City of **HOBART**

## APPLICATION UNDER HOBART INTERIM PLANNING SCHEME 2015

Type of Report: Committee  
Council: 23 July 2018  
Expiry Date: 26 July 2018  
Application No: PLN-18-131  
Address: 90 LIVERPOOL CRESCENT , WEST HOBART  
ADJACENT ROAD RESERVE  
Applicant: Ryan Strating (Core Collective Architects)  
Level 1  
30 Argyle Street  
Proposal: Dwelling  
Representations: None  
Performance criteria: Low Density Residential Zone Development Standards, Parking and  
Access Code

Fig. 5. Proposed site plan.

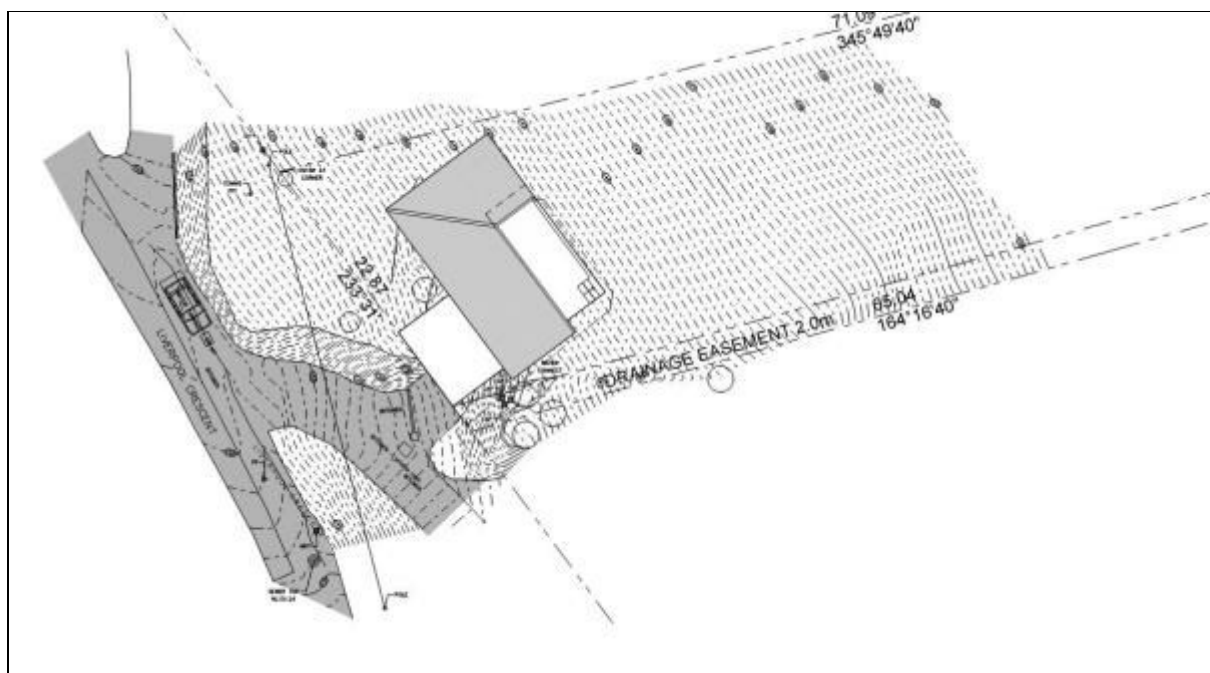
6.7.5 The only non-compliant part of the dwelling is the garage; the rest of the dwelling is set back 4.5m and so meets the acceptable solution. The setback is in response to the slope and excavation constraints of the site and so meets (a). There is a very wide road reserve, with the result that the garage is set back 11.0m from the edge of the road carriageway. Because a wide section of the road reserve looks like it is part of the lot, the garage appears to be set back much further from the lot frontage than it actually is. This significantly reduces any impact on streetscape and so (b) is met. The GIS images below show the extent of the road reserve.

6.8.2 The proposal includes a garage that is sited directly on the front boundary. The slope is around 1 in 3, so the garage should be setback at least 1.0m to meet the acceptable solution.

6.8.5 The garage location allows for passive surveillance between the dwelling and the street. For the reasons stated above in 6.7.5, the garage does not adversely affect streetscape and takes into account the topographical constraints of the site.

Fig. 6. Proposed north-east and south-east elevation.

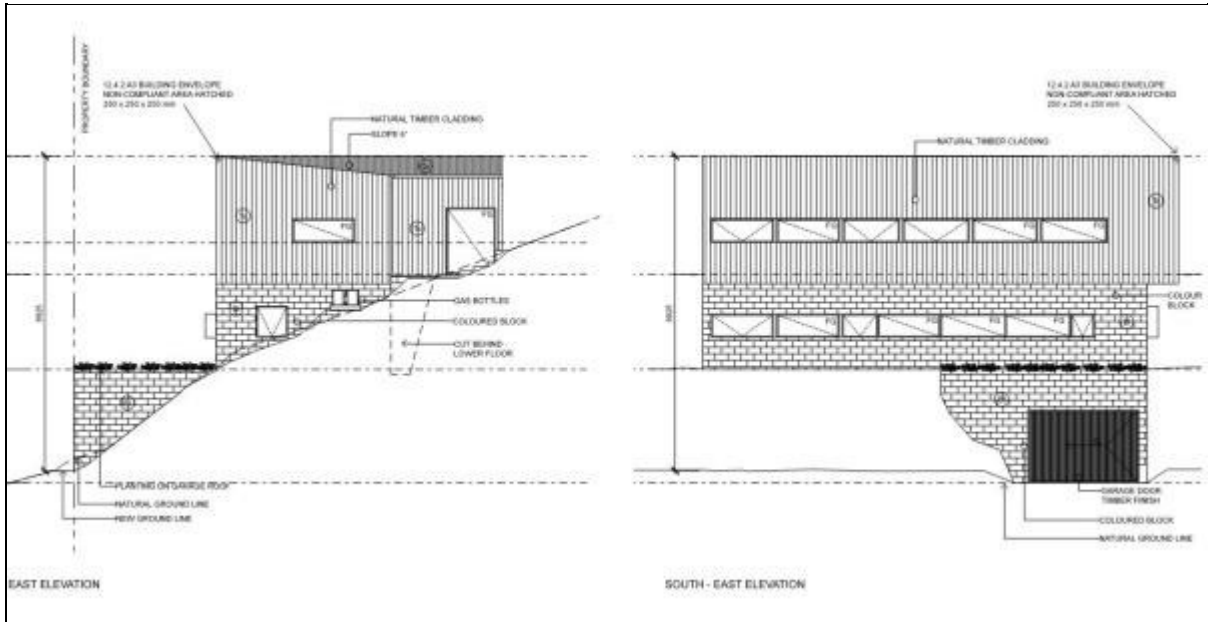
6.9.2 The proposal includes a building which has parts of the south-west and north-east elevations outside the building envelope.

6.9.5 Most of the dwelling is within the building envelope. Both the south-west and north-east elevations are at angles to the side boundary, with varying setbacks and varying wall heights, so only a small part of these elevations are outside the envelope. The dwelling is outside the envelope at the south-west elevation where the wall is set back 1.0m and is 4.4m high and at the north-east elevation where the wall is set back 2.74m and is 6.7m high. The degree of discretion is very small, with only the top part of the wall outside the envelope. The roof has a shallow 6 degree pitch, and so unlike a steeply pitched roof, does not contribute to any overshadowing.

*Fig. 10. Western (side) elevation of the dwelling at 88 Liverpool Crescent, to the east of the subject site. Source: Documents approved under PLN-12-00316.*

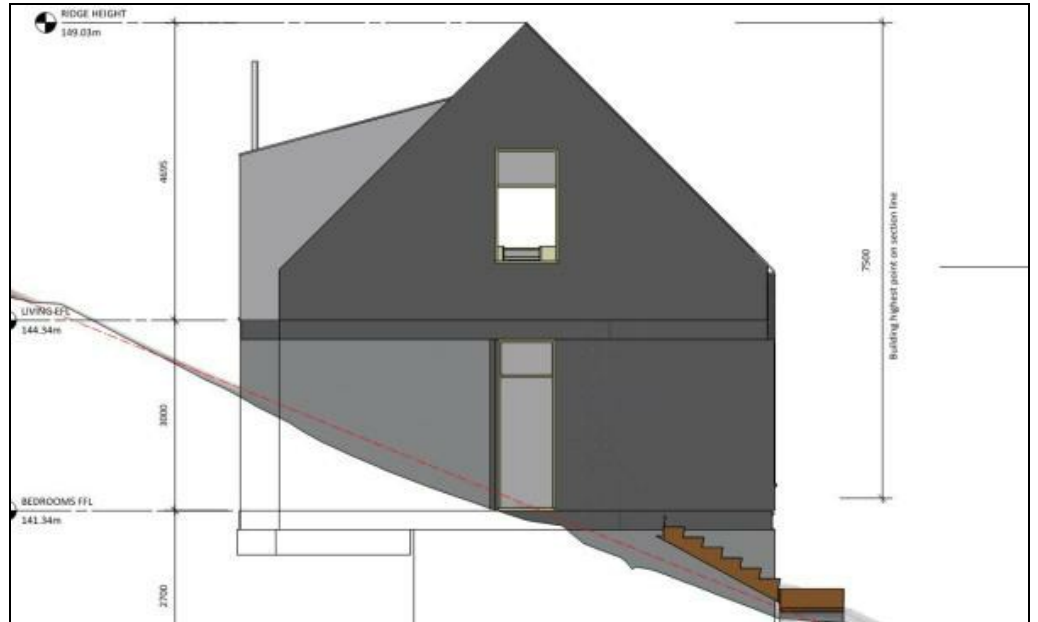
- 6.9.9 The upper level window on the neighbour's western elevation is part of a short hallway at the top of the internal staircase. There is a wall between this area and the adjacent living area. There is a doorway in this wall which would let sunlight through from the window, but this window is clearly not intended to be the main source of light into this room. The main source of light is the large north facing bank of windows looking over the rear garden. The northern elevation is unaffected by the proposed dwelling at 90 Liverpool Crescent. The impact on the western facing window would be limited and would not impact significantly on the amount of sunlight that the living area receives during the day. Performance criterion 12.4.2 P3 (a)(i) is therefore met in relation to this window.

*Fig. 11. Internal schematics showing the western (side) and southern (front) elevations of the dwelling at 88 Liverpool Crescent, to the east of the subject site. Source: Documents approved under PLN-12-00316.*

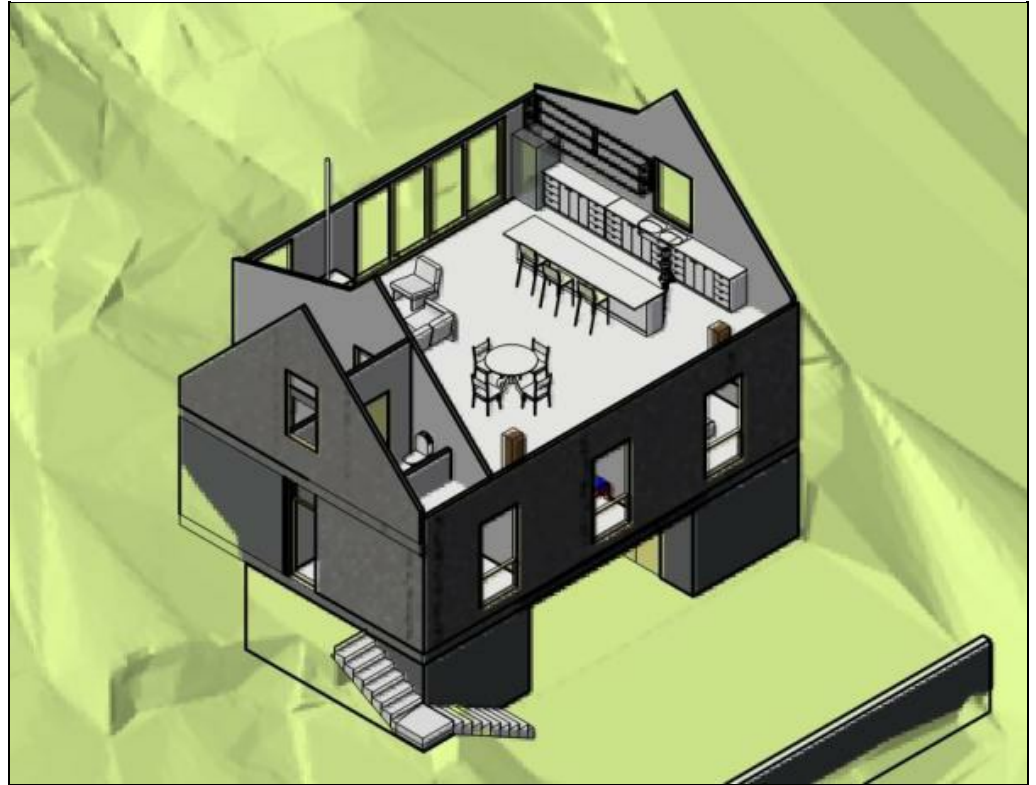
- 6.9.10 The lower level window on the western elevation provides light to the room called play/music/laundry room on the floor plan approved under PLN-12-00316. The northern side of this room was designed to be set into the hillside and so there are no north facing windows. The only source of light into this room is from the western facing window and from the southern facing bedroom windows above the garage. The rear of the proposed dwelling is set back 10m from the front of the lot and so is approximately half way alongside the neighbour's western elevation, and terminates near the play/music/laundry room window (refer Fig. 12 below). The proposed dwelling is single storey at this point and set back 4.7m from the boundary and so would not have an unreasonable overshadowing impact on this window. Performance criterion 12.4.2 P3 (a)(i) is therefore met in relation to this window.
